Nine Mile Point Nuclear Station

January 31, 2005
NMP1L 1922

License Renewal Application – Responses to NRC Requests for Additional Information Regarding Sections 2.2, 2.3.3, and 2.3.4, and Scoping and Screening Methodology (TAC Nos. MC3272 and MC3273)

Constellation Energy	NINE MILE POINT NUCLEAR STA-UNIT 2
PIPING & INSTRUMENTATION DIAGRAM	DIGITAL RADIATION MONITORING SYSTEM
OFFLINE LIQUID MONITOR	Service Water System
DATE: 11-81	REV: 1
SCALE: NONE	LR-400758
DESIGNED BY: NONE	Rev. 0

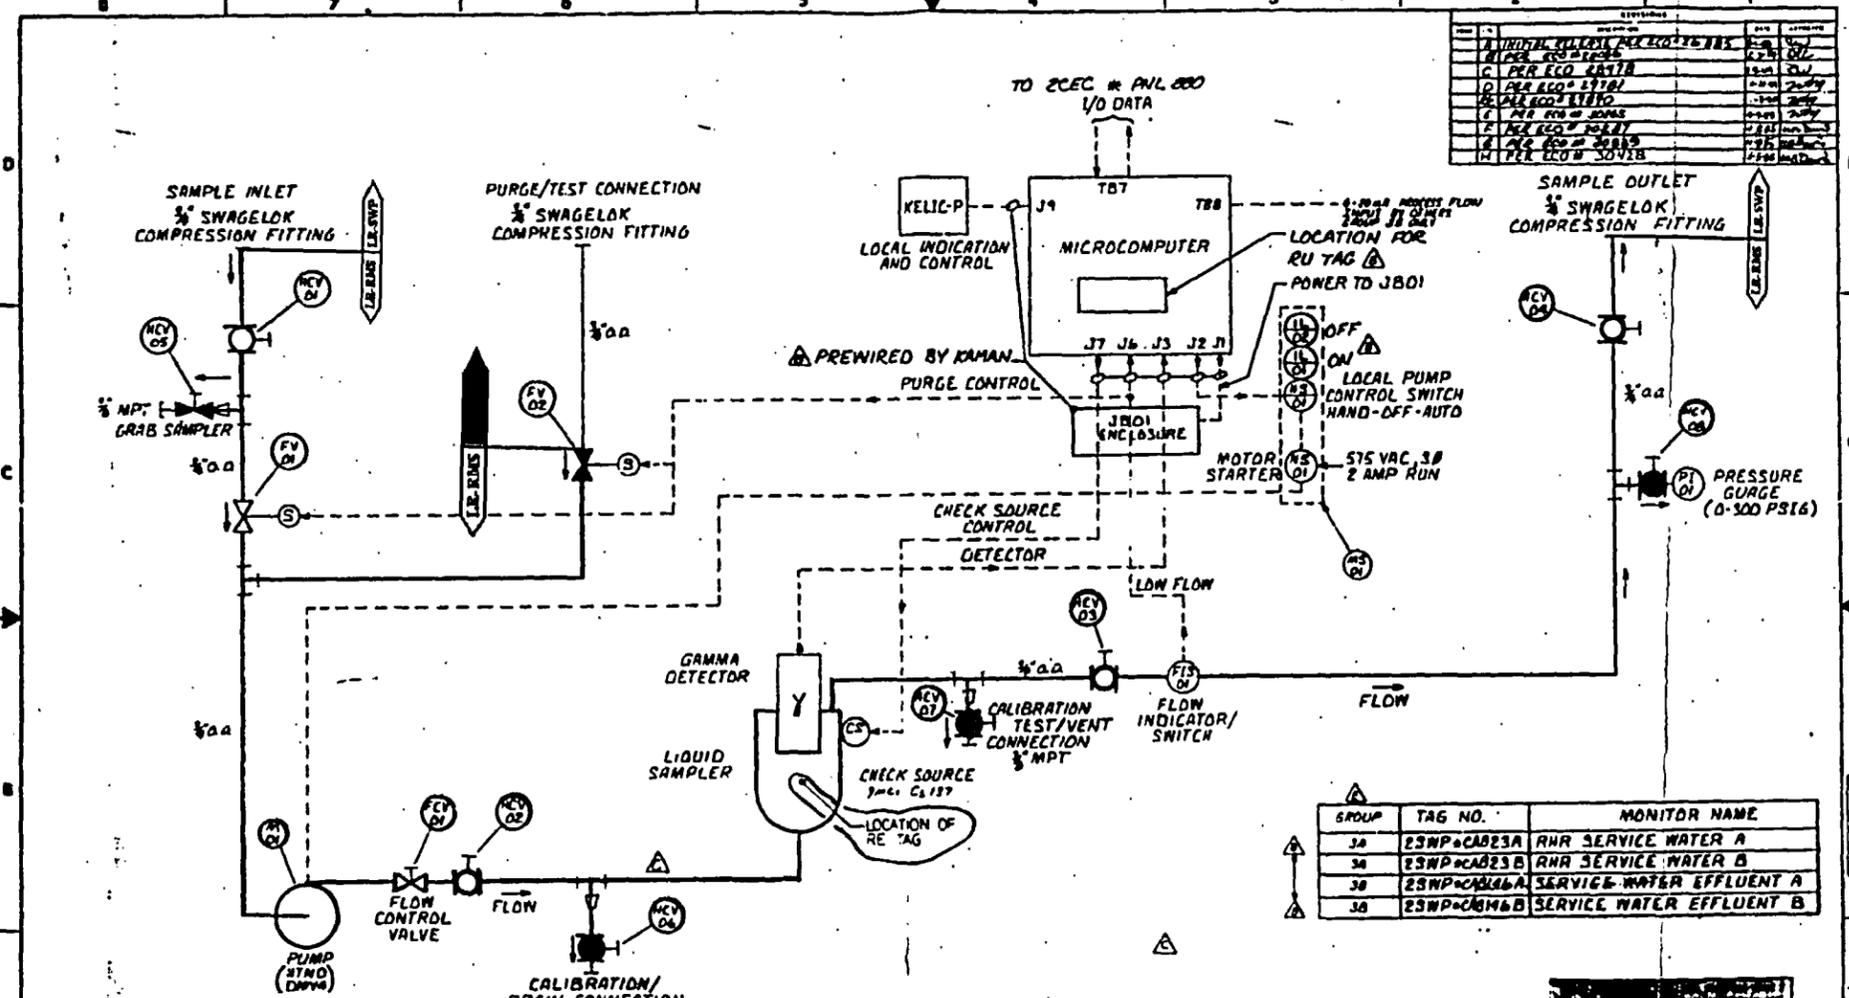
LRA Section 2.3.3.B.22 regarding the NMP2 radiation monitoring system states that “portions of the system consists of off-line gas and liquid monitors which consist of piping, filters, pumps, sampler/detectors, valves, and instrument.” The applicant did not identify the radiation monitoring system components that are in scope of license renewal due to 10CFR54.4(a)(1) and 10CFR54.4(a)(2). Furthermore, an LR drawing for the NMP2 radiation monitoring system was not provided to show the portions of this system containing components within the scope of license renewal. Please identify the components of the radiation monitoring system that are in-scope of license renewal in accordance with the requirements of 10CFR54.4(a)(1) and 10CFR54.4(a)(2), and justify the exclusion of these components from being subject to an AMR in accordance with the requirements of 10 CFR 54.21(a)(1).

The NMP2 Radiation Monitoring System contains components that are subject to aging management review; however, they were inadvertently omitted from the original LRA. These components are the piping, pumps, filters, flow elements, and valves that allow sampling of the process system fluid for radioactivity. The process systems that are monitored for radioactivity and whose radiation monitoring function are within the scope of license renewal are the Containment Monitoring (CMS), Control Building Ventilation (HVC), Reactor Building Ventilation (HVR), and Service Water (SWP) Systems. The results of the aging management reviews conclude that for the CMS, HVC and HVR systems, there are no aging effects since the components are made of wrought austenitic stainless steel and are exposed to an Air environment. For the radiation monitoring components in the SWP system, they are also constructed of wrought austenitic stainless steel but are exposed to a Raw Water environment. As such, the applicable aging effect is Loss of Material due to pitting, crevice, and microbiologically influenced corrosion. The associated aging management program is the Preventive Maintenance Program. Corresponding LRA revisions are described below.

- LR-11, Sheet C, Service Water System
- LR-11, Sheet H, Service Water System
- LR-11, Sheet P, Service Water System
- LR-52, Sheet G, Reactor Building Ventilation
- LR-53, Sheet B, Control Building Ventilation
- LR-82, Sheet A, Containment Atmosphere Monitoring
- LR-400758, P&ID DRMS Offline Liquid Monitor Service Water System
- LR-400759, P&ID DRMS Offline Gas Particulate Monitor Reactor Building Ventilation
- LR-400762, P&ID DRMS Offline Gas Monitor Control Room Ventilation
- LR-400863, P&ID DRMS Offline Gas Particulate Monitor Containment Monitoring System”
